**Topgolf - Germantown: Preliminary Plan Amendment No. 12007065B and Site Plan No. 820170010**

**Completed: 07-07-17**

**B. Topgolf - Germantown: Site Plan No. 820170010:**

**Applicant:** Topgolf USA Germantown LLC

Figure 11: Public Use Space exhibit

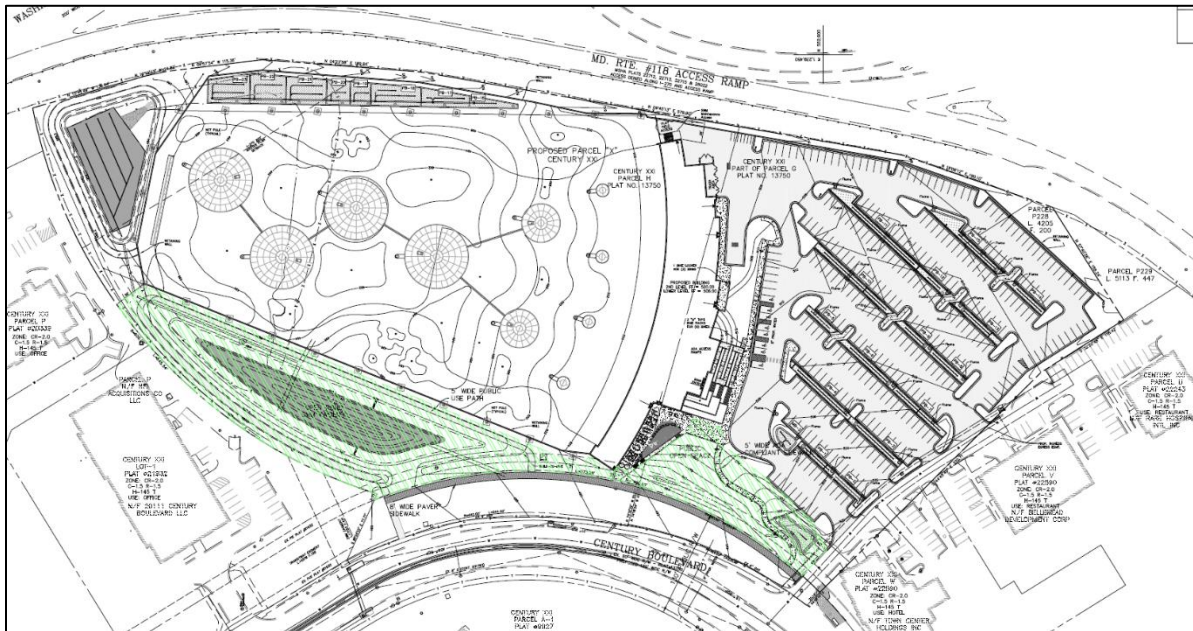
As conditioned, the Site Plan adequately meets the Public Open Space requirements as detailed in the Open Space Applicability section of the zoning ordinance. The Public Open Space provided is devoted to public use and enjoyment and attracts public appreciation due to its location, amenities, and additional design elements to be provided. The Site Plan exceeds the minimum 10 percent requirement, by providing a total of 13.2 percent, or 66,500 SF, of the tract area as Public Open Space that is divided into two major areas (Figure 11). As required, both of these areas abut the public sidewalk along Century Boulevard, exceed the 15-foot minimum width, include seating and shading, and are one contiguous space.

First, the patio and lawn area is located between the building's main entrance and the Century Boulevard ROW (Figure 12). Consistent with the Zoning Ordinance requirements, and Sector Plan's recommendations, this space is intended to serve primarily three goals: 1) street activation, 2) connectivity, and 3) placemaking.

Connectivity between the sidewalk on Century Boulevard and the main entrance of the building is partially achieved with two separate lead-in sidewalks from Century Boulevard that lead to the terraced planters near the main entrance of the building. As conditioned, Staff recommends that the terraced planters accommodate steps facing the public sidewalk and the public open space in addition to the steps facing the parking lot. Division 4.5.3 requires that the building's main entrance face a street or open space. By providing additional steps that face the street and open space, the Site Plan will provide adequate

Placemaking goals are highlighted throughout the Sector Plan, which specifically identifies this Property as a landmark site. Staff recommends better articulation of the lawn area to create a more usable public open space with distinguishing features to celebrate it as a landmark site. The recommendations to expand the lawn games area, re-align the path connection and provide additional access to the main entrance of the building will reinforce this Property as a landmark site and better anchor the Topgolf facility in the fabric of the Germantown Town Center.

- a) The Applicant must provide a minimum of 66,500 square feet of public use space (13.2% of net lot area) on-site.
- b) Prior to Certified Site Plan, Applicant must work with M-NCPPC Staff to incorporate additional design elements that engage the public open space and sidewalk on Century Boulevard, including, but not limited to, the following:

- i. Steps through the terraced planters ("Staircase") leading up to the building's main entrance in a similar manner as the steps provided through the terraced planters facing the parking lot.

Figure 14: Front elevation

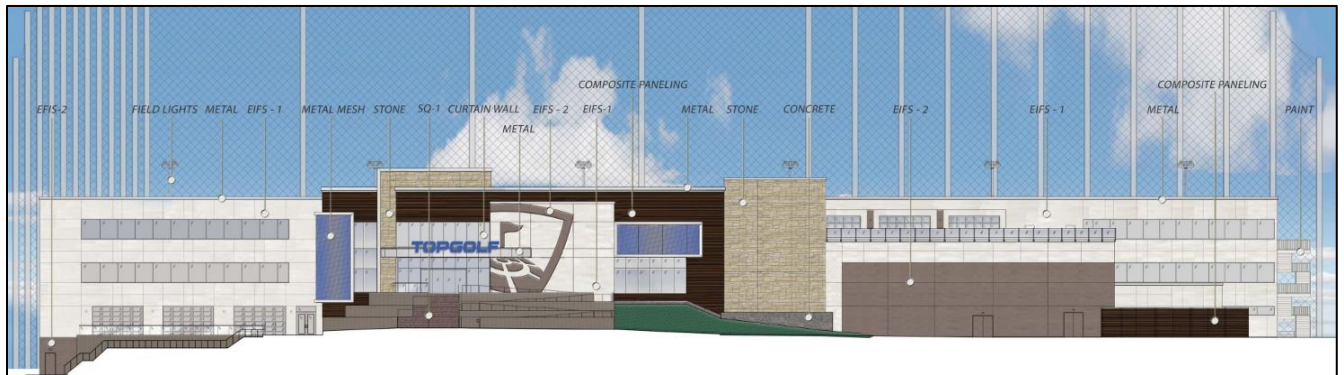
The three-story building is generally long and skinny with a solid façade on the building front and sides, and an open frame with golf hitting bays at its rear. The building front faces south over the parking lot, but is angled slightly to be highly visible from Century Boulevard. The front façade includes the front door, a grand staircase, signage and façade articulation (Figure 14). The open golf bays are on the north side of the structure, and are stacked three bays high by 34 bays wide (Figure 15). Extending over 600 feet from the north side of the building is the outfield area where patrons hit the golf balls into. The outfield is a specific design unique to Topgolf with varied topography and numerous recessed areas that facilitate the scoring in the games offered by Topgolf.

The architectural treatment of the building is compatible with adjacent development and reinforces the Sector Plan's vision of a landmark site. The front façade includes various materials and large areas of glass in addition to two panels of color changing LED washing metal mesh. The two short sides of the building, roughly facing east and west, are wrapped in similar materials as the front, and include numerous windows.

- 7. Site Design
  - a) The exterior architectural character, proportion, materials, and articulation must be substantially similar to the schematic elevations of the submitted architectural drawings submitted via ePlans, as determined by M-NCPPC Staff.

- b) Applicant must provide LED color changing mesh panels as shown on architectural elevations of the Certified Site Plan.
- 8. Landscaping
  - a) The Applicant must install the site elements as shown on the landscape plans submitted to MNCPPC, or approved equivalent.
